# Access Compliance Report

## Public Rights-of-Way

Intersection ID: 10040790	Main Street: W_W_T_HARRIS_BV	Cross Street: N/A	Location: NE
ADA ID: 3397FD6DFB75	Ramp Type: Perp	Initial Pass/Fail: Fail	Overall Compliance: No
Severity Score: 1.25			
Codes/Mitigation Info/Possible Solution		Field Measurements/Component Compliance

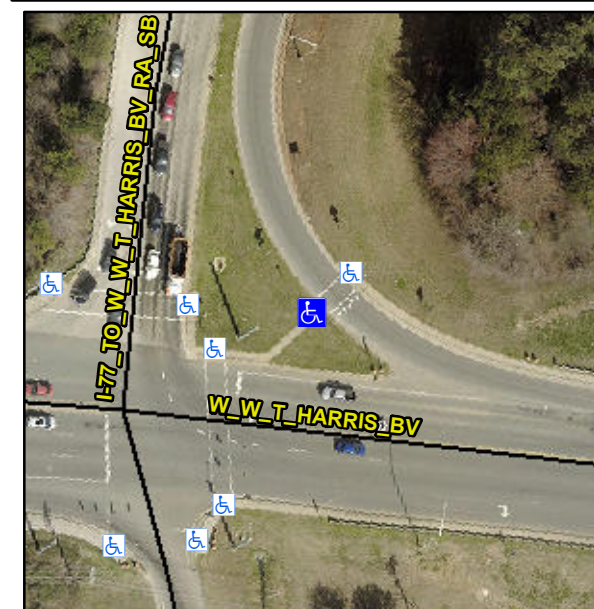
**Not Found, R304.5.3**

Compliance	Description	Data	Compliance	Description	Data
N/A	Ramp Length (in)	60.0	Yes	Ramp Slope (%)	6.7
Yes	Ramp Width (in)	53.0	No	Ramp XSlope (%)	2.9
N/A	Flare Type LT	N/A	N/A	Flare Type RT	N/A
N/A	Flare Slope LT (%)	N/A	N/A	Flare Slope RT (%)	N/A
N/A	Flare Traversable LT?	N/A	N/A	Flare Traversable RT?	N/A
N/A	Landing Length (in)	N/A	N/A	DWS Provided?	N/A
N/A	Landing Width (in)	N/A	N/A	DWS Contrast?	N/A
N/A	Landing Slope (%)	N/A	N/A	DWS Length (in)	N/A
N/A	Landing X Slope (%)	N/A	N/A	DWS Full Width?	N/A
N/A	Landing Curb? (Y/N)	N/A	N/A	DWS Offset (in)	N/A
N/A	Shared Landing?	N/A			
N/A	Gutter Ponding?	N/A	N/A	Gutter Slope (%)	N/A
N/A	Gutter Lip Ht (in)	N/A	N/A	Gutter X Slope (%)	N/A
N/A	Painted X Walk1?	Yes	N/A	Painted X Walk2?	N/A
	X Walk 1 Direction	To NE		X Walk 2 Direction	N/A
N/A	X Walk 1 Width (in)	118.0	N/A	X Walk 2 Width (in)	N/A
	X Walk 1 Slope (%)	0.5		X Walk 2 Slope (%)	N/A
	X Walk 1 X Slope (%)	2.1		X Walk 2 X Slope (%)	N/A

**Remove & Replace Entire Ramp.**
